CITY OF EVERETT
Purchasing Department
484 Broadway, Room 14
Everett, MA 02149

ADDENDUM 1

EXAMPLE 1 – SPLIT RAIL FENCE

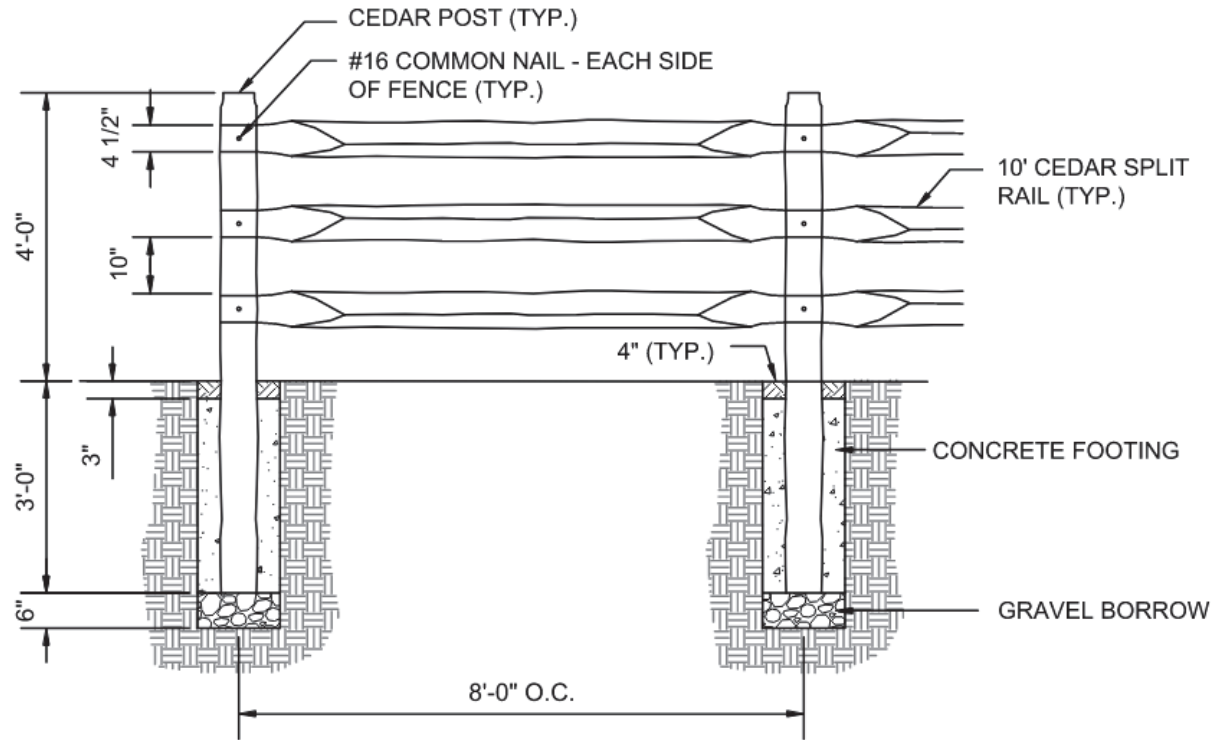
The two-rail cedar split rail is generally a 3' high fence – is that acceptable?

Is it actual post and rail and do you have any drawings of the fence?

Please see attached drawing

Please see attached drawing
